The Commission has issued the enclosed Amendment No. 70 to Facility Operating License No. DPR-64 for the Indian Point Nuclear Generating Unit No. 3. The amendment consists of changes to the Technical Specifications in response to your application transmitted by letter dated June 13, 1986.

The amendment revises the Technical Specifications to permit storage of fuel having enrichment up to 4.3 weight percent U-235 in the fresh and spent fuel racks.

Amendment No. 70
License No. DPR-64

SAFETY EVALUATION BY THE OFFICE OF NUCLEAR REACTOR REGULATION
RELATED TO AMENDMENT NO. 70 TO FACILITY OPERATING LICENSE NO. DPR-64

FIGURE 3.8-1

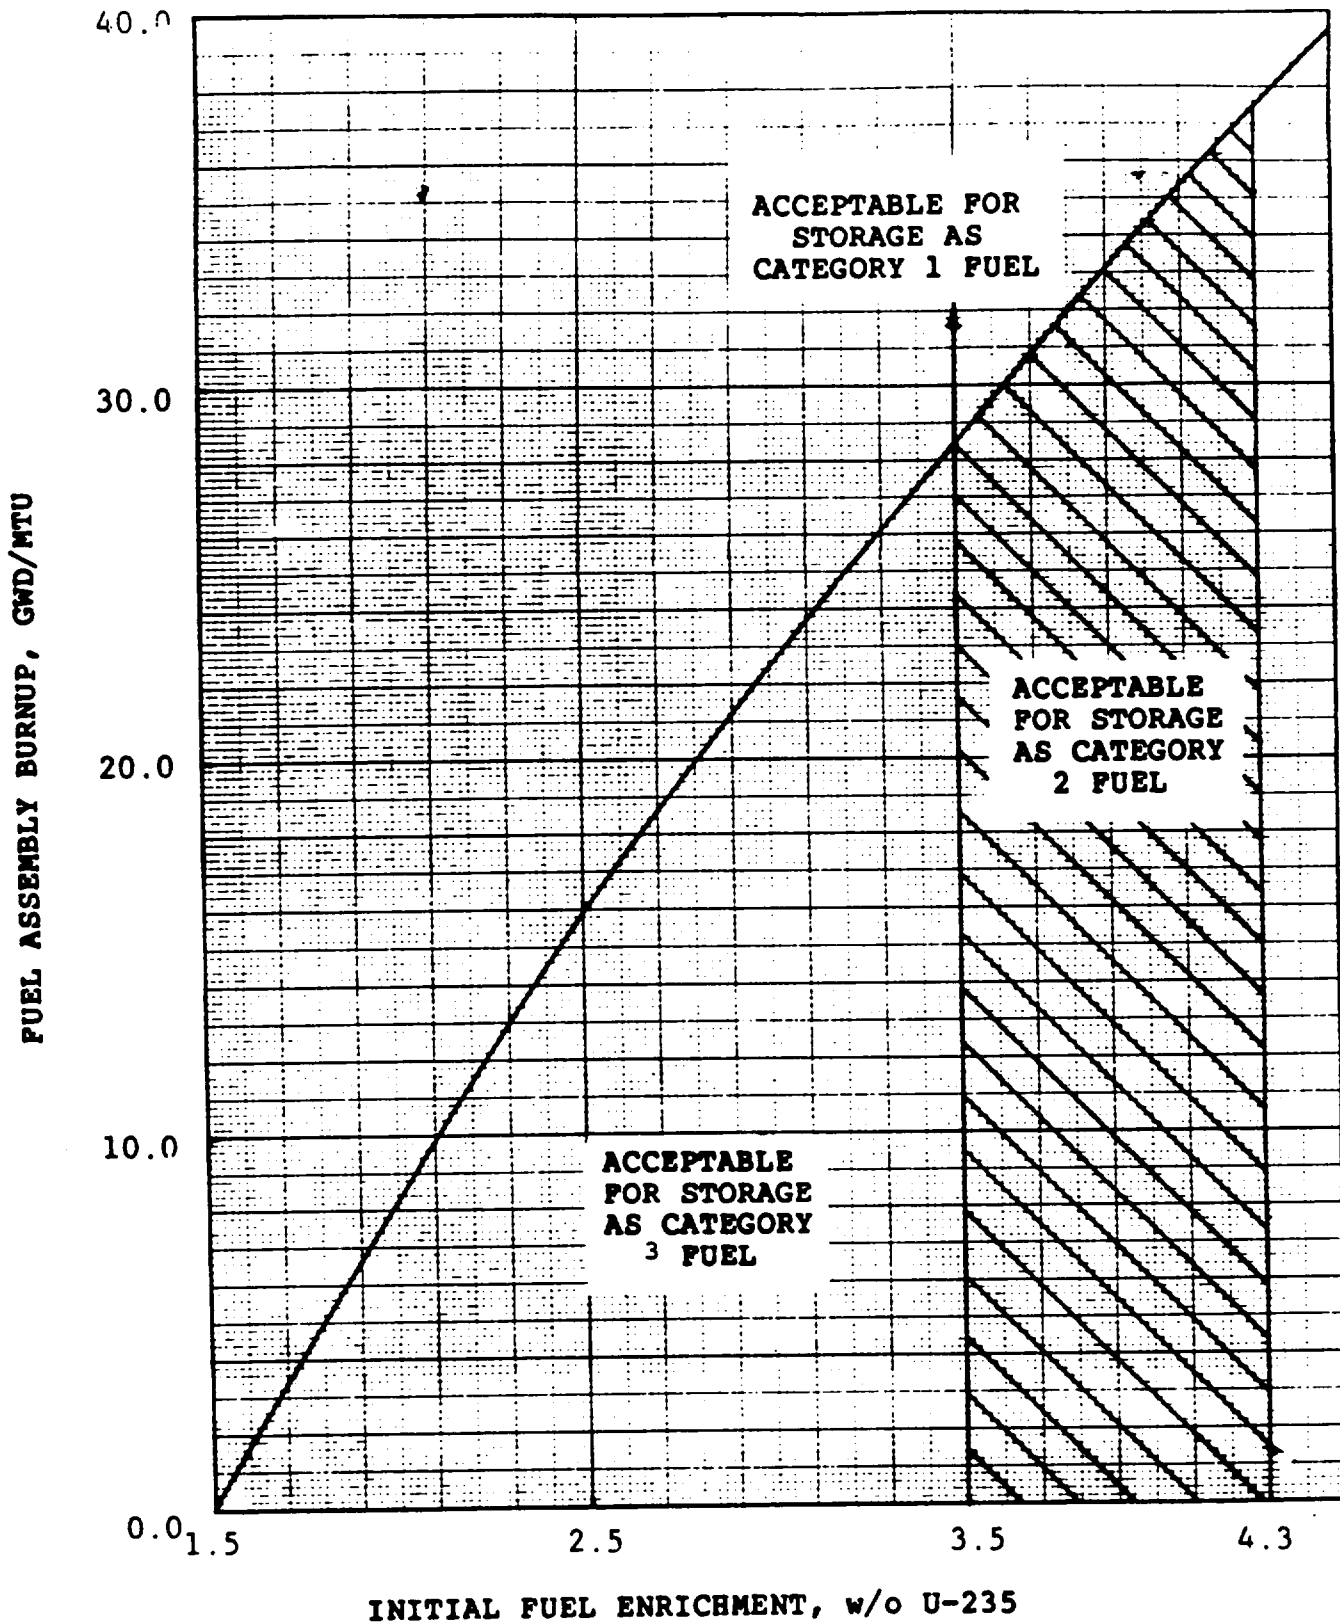
7. Fuel assemblies to be stored in the spent fuel pit can be categorized as either Category 1, 2 or 3 based on burnup and initial enrichment as specified in Figure 3.8-1. Category 2 fuel shall be loaded into the spent fuel pool storage locations in a checkerboard fashion with the intermediate storage locations containing Category 1 fuel, non-fuel materials or left empty. Unless restricted by the above, Category 1 or 3 fuel can be stored in any location in the spent fuel pool.

Fuel assemblies whose initial enrichment is greater than 3.5 w/o U-235 but less than or equal to 4.3 w/o can be stored in the spent fuel pool providing they are placed in a checkerboard array with fuel whose initial enrichment and burnup are sufficient to ensure that K_{eff} is less than 0.95 with no soluble boron present. This is ensured by categorizing the fuel whose initial enrichment is greater than 3.5 w/o U-235 but less than or equal to 4.3 w/o and whose burnup is below the curve of Figure 3.8-1 as Category 2. This fuel can be stored by checkerboarding with Category 1 fuel which is defined as fuel whose initial enrichment and burnup place it on or above and to the left of the curve in Figure 3.8-1. Category 3 fuel which is less than or equal 3.5 w/o U-235 and below the curve of Figure 3.8-1 cannot be used in the checkerboard with Category 2 fuel. Any Category 1 or 3 fuel can continue to be stored on a repeating x-y array with other non-Category 2 fuel. For the purpose of storing Category 2 fuel, non-fuel material or empty locations can be utilized in place of Category 1 fuel.

The licensee has proposed changes to Sections 3.8, 5.3 and 5.4 of the IP3 Technical Specifications. Section 3.8 has been amended to include the curve of required burnup as a function of initial enrichment and the restrictions on the storage of fuel with enrichment between 3.5 and 4.3 weight percent U-235. We have reviewed the proposed changes and conclude that they are consistent with the analysis provided and are acceptable. The changes to Sections 5.3 and 5.4 are merely to change the maximum permitted enrichment from 3.5 to 4.3 weight percent U-235 and are acceptable.

The method used for obtaining the constant reactivity curve for required burnup as a function of enrichment is the standard one used for rack criticality evaluations and is acceptable. The application of this method to the evaluation of checkerboard loading is also acceptable. The required burnup curve is obtained by first evaluating the rack multiplication factor for a checkerboard array consisting of fresh 4.3 weight percent and 1.5 weight percent U-235 fuel in alternating (checkerboard) locations. The value obtained for the multiplication factor was 0.901 for the Type A racks and 0.906 for the Type B racks. Next burned fuel having an initial enrichment greater than 1.5% weight percent was substituted for the 1.5 weight percent fuel and the burnup of that fuel was varied until the same multiplication factor was obtained. This process was repeated for several initial enrichment values up to 4.3 weight percent U-235. A curve of required enrichment as a function of burnup was then constructed and is included in the proposed Technical Specifications.
